| Project | IEEE 802.16 Broadband Wireless Access Working Group http://ieee802.org/16 > | | | | | |
| Title | Solution upon the AIs in 46 meeting. | | | | | |
| Re: | 80216h-06_028: Title: TGh Report closing plenary- Meeting 46 (2006-11-17) | | | | | |
| Abstract | Feedback on the AI summarization C80216h-06_123.xls | | | | | |

Change figure h11 as indicate:

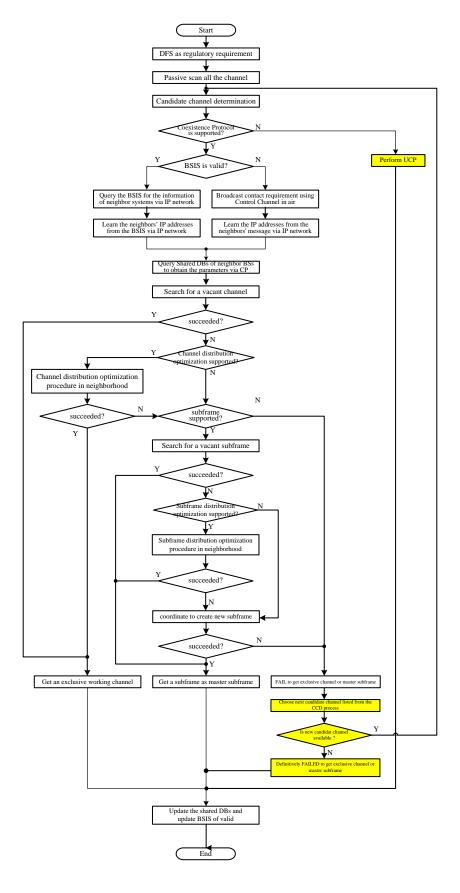
| up-date the figure | 211 | confirmed | Xuyong | figure h11 is confirmed by mariana |

Comment 211 resolutions:
